Review of the Applicant's Technical Note [[REP3-038](#)].

The Applicant's response to the ExA request at [ISH2](#) for a Technical Note was submitted at Deadline 3. The narrative and figures are mostly from previous submissions, although there are new details and insights.

Figure 6-6 in Statement of Need © BOOM

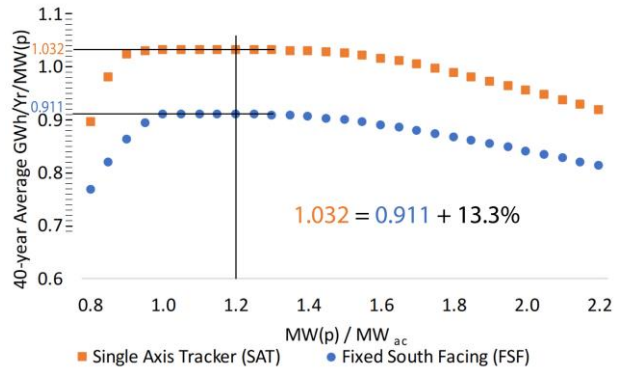
The PVsyst simulated performance advantage (12.3%) of SAT over FSF [5.1.8] is supported by the graphical analysis presented in Figure 3 (Figure 6-6 in the Statement of Need), with a measured SAT advantage of 15% [5.1.7].

In fact, careful measurement of the graphical data elicits an energy advantage 13.3% at 1.2 overplanting, which is an even better match to the declared PVsyst value.

However, there are features of these curves that call into question the integrity of the presented graphical data.

Fig 6-6 in Statement of Need © BOOM Power Ltd

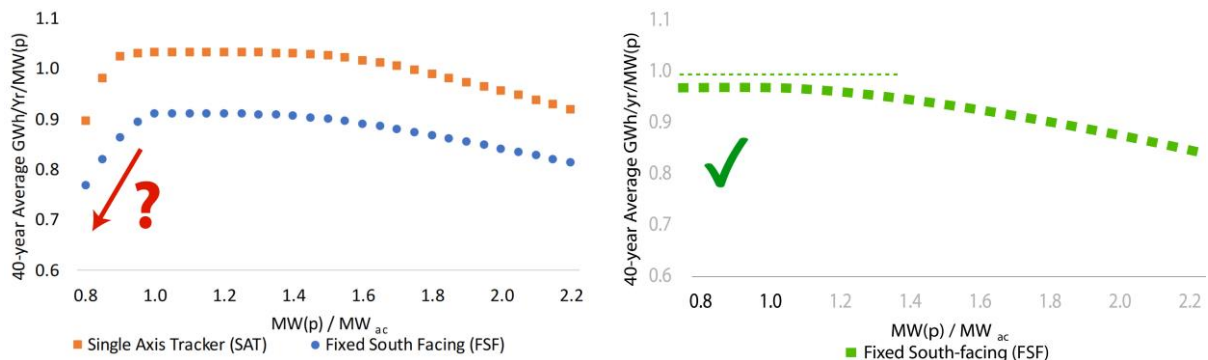
- A.1 Most glaringly, the curves have the wrong shape. We cannot test the absolute values, but we can be certain that the energy-per-panels value will reach a maximum at 1.0 and remain at that level as the ratio decreases further (i.e. a horizontal line in graphical representation). No explanation has been offered for the droop below 1.0.

Fig 6-6 in Statement of Need © BOOM Power Ltd

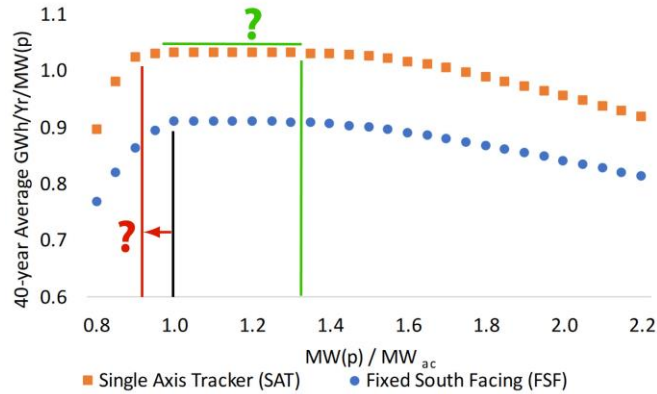
A.3 There are artifacts in the graph that one commonly associates with hand-drawn curves. For example, the droop (for whatever reason) starts at 1.0 for FSF. But the equivalent point for SAT has shifted to nearer 0.9 (red): visually more appealing, but how is this scientifically possible? And, how is it that overplanting has zero detectable effect on SAT 40-year panel yield until planting exceeds 1.3 (green)?

Figs 6-5 in Statement of Need: original (left) and Rev 01 (right) © BOOM Power Ltd

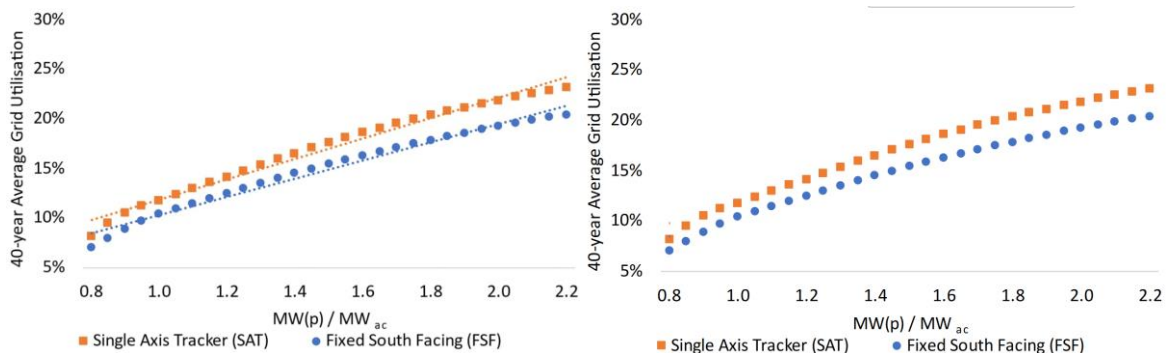
A.4 Related figure: The discredited [REP2-026] “straight lines of best fit” in Fig 6-5 have been discretely removed in the latest revision of the Statement of Need.

This editing must have been performed in haste. The associated paragraphs [6.6.29, 6.6.30] still draw conclusions from the (now non-existent) straight lines of best fit. These paragraphs too should be removed.
